STUDIO ASTRAGAL

**HERITAGE IMPACT ASSESSMENT
OF PROPOSED INTERNAL AND EXTERNAL ALTERATIONS
INCLUDING RECONSTRUCTION OF A CONSERVATORY
10 REGENT'S PARK TERRACE, LONDON NW1**

**For
Mr Godeau & Ms Gastaldo
January 2017**

The Rear Façade

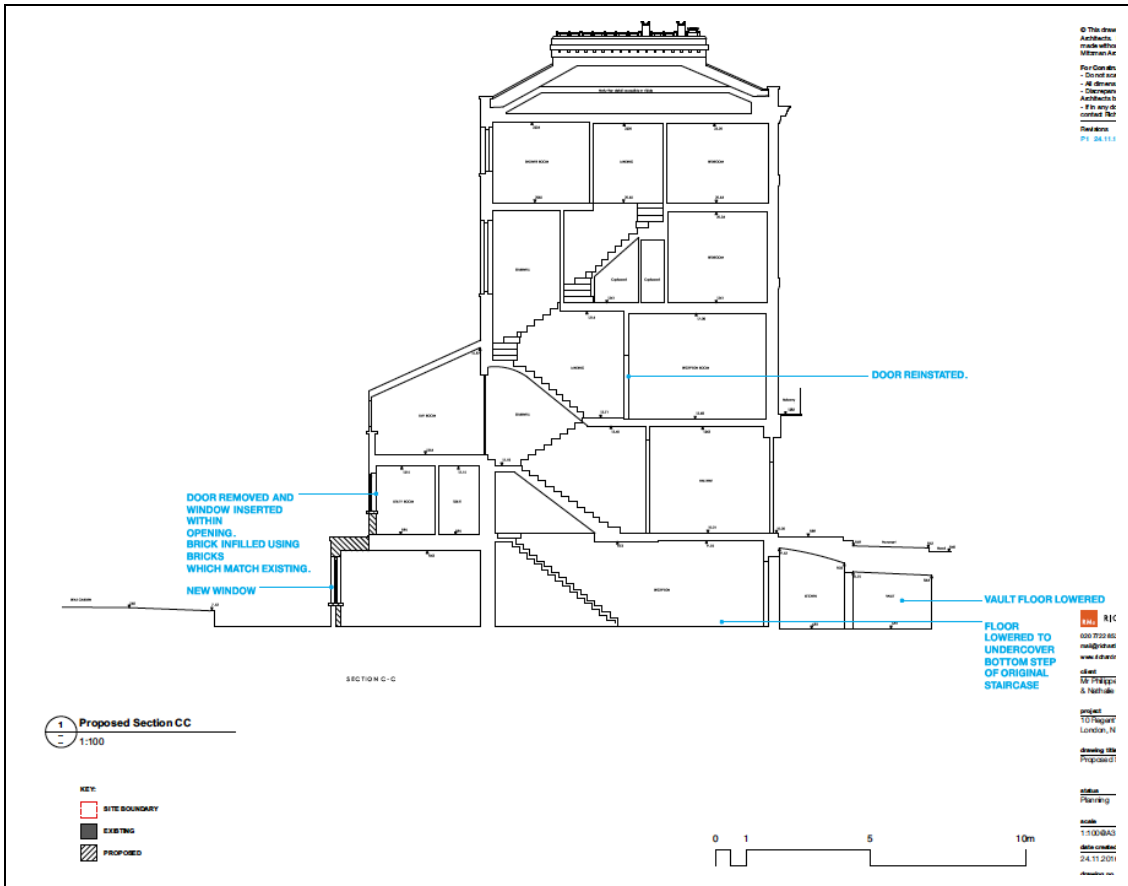
- 5.12 The proposed new windows on the rear wing are not consistent in their heights, positioning on the facades, fenestration subdivisions and pane sizes either with each other or with the

historic windows on the north elevation. The new basement rear window is taller than the historic ones on the ground floor, which inappropriately inverts the architectural hierarchy of the building. Their heights, positions of cills and heads in relation to the floor levels and their windowpane divisions should all match those of the existing historic sash windows of the rear wing.

- i) Form a parapet with a stone coping and brick dentils to match the original roof parapets of the building proposed raised roof of the single-storey rear extension to rear wing.
- ii) Make all the new windows on the rear wing the same heights with their cill and head levels the same height above floor levels and with the same pane divisions and sizes as the existing historic windows on the north elevation.
- iii) Form a brick segmental arch above it to match the originals above the proposed basement window in the back wall of the rear wing.
- iv) Replace the basement rear conservatory with a correctly detailed period design with doors that match the design of the first-floor half-landing French doors.

drawing title
 Proposed Lower Ground Plan

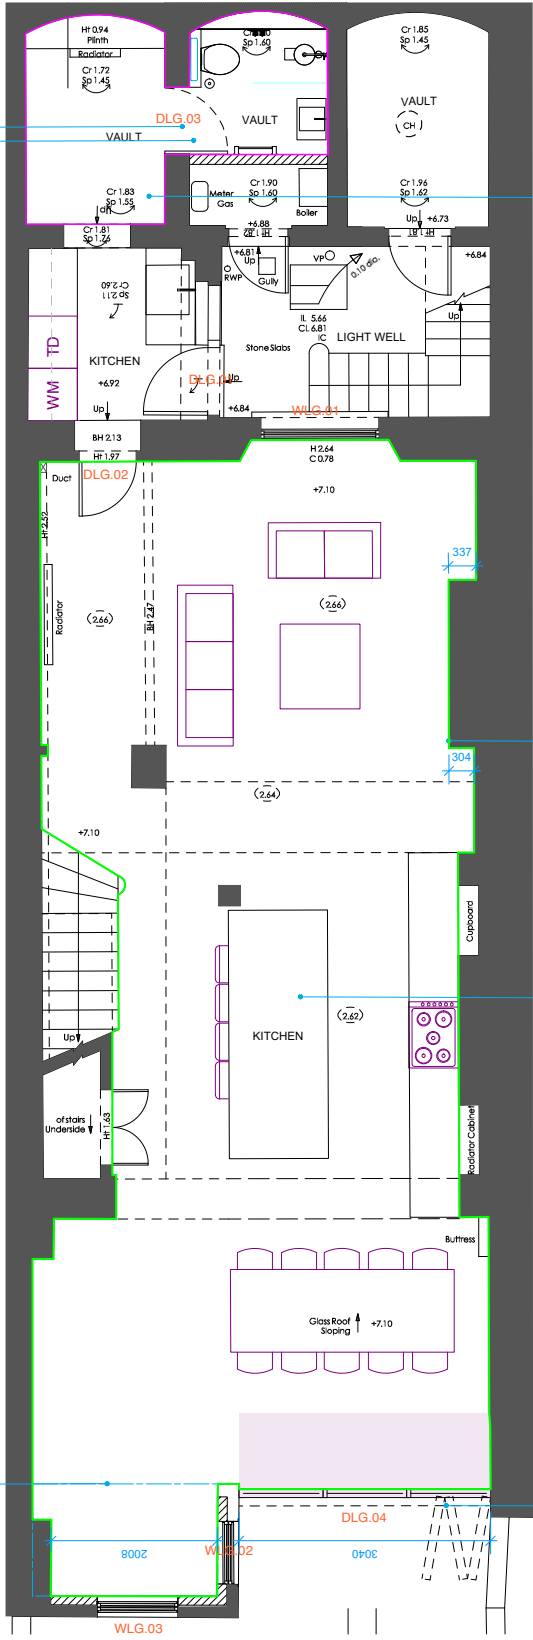
5.13 It is proposed to form an opening between the south and middle front vault, partition off most of the back of the middle vault, line them with a Delta waterproofing membrane and create a bathroom in the middle vault. The floor level in the main basement would be lowered to its original level, exposing the bottom step of the stairs. The kitchen would be relocated from the ground floor to the rear main part of the basement. The remaining column of the original main back wall and most of the remaining part of the north flank wall of the rear wing would be removed. The new conservatory would extend further out than the existing one.

- 5.14 All the internal walls and most of the external walls at the rear have been removed. The cumulative impact of both past and proposed future alterations needs to be considered. It should be noted that some of the past removals of walls appear to be unauthorised. Removal of the remaining historic fabric of the original main back wall of the building and north side wall of the rear wing would the complete loss of definition of the original internal and external plan forms of the building at this level. This would appear to conflict with Sections 138 and 149 of Historic England's Conservation Principles - Policies and Guidance and Section 42 of their Advice Note 2 - Making Changes to Historic Assets and Section 6.16 of BSI's BS 7913:2013 - Guide to the Conservation of Historic Buildings.

- 5.18 There is no information on the drawings about ventilation for the new bathroom and kitchen and so the potential heritage impacts of these cannot be assessed.

- 6.11 The works to the front vaults: Whilst Local Planning Authorities do grant permission for such sealed membrane systems to be installed in the vaults of Listed buildings, conservationists do have reservations about them and prefer ventilated systems. Their concerns are that sealed membrane systems prevent evaporation of damp away from the walls and vaulting. This could result in a higher moisture content in the masonry and there are fears that this might cause mechanical and chemical breakdown of the bricks and lime mortar over time. They also have concerns that the laying of a concrete foundation with a damp proof membrane on top could trap damp below it and drive it to the walls, thus increasing the moisture content in the walls. However, it is difficult to see how a satisfactory vented system could be devised for a barrel-vaulted ceiling. Insulation is advisable and this might be achieved by direct application of an insulating plaster to a meshed membrane system.

- 6.12 There is no indication of any mechanical ventilation of the new bathroom, which is highly advisable. The lowering of the floor will necessitate removing the skirting boards and probably replacing these, the door architraves and possibly the door to the utility room. The opportunity could be taken to replace this modern inappropriate off-the-shelf joinery with more appropriate bespoke designs.

- 6.13 The following amendments are recommended:-
 - i) Retain the remaining parts of the original main back wall and north wall of the rear wing.
 - ii) Reinstatement of some of the original walls in the basement and the original rear main wall, including deep downstands above openings in order to structurally strengthen the building and reinstate its original plan form and compartmentalisation.
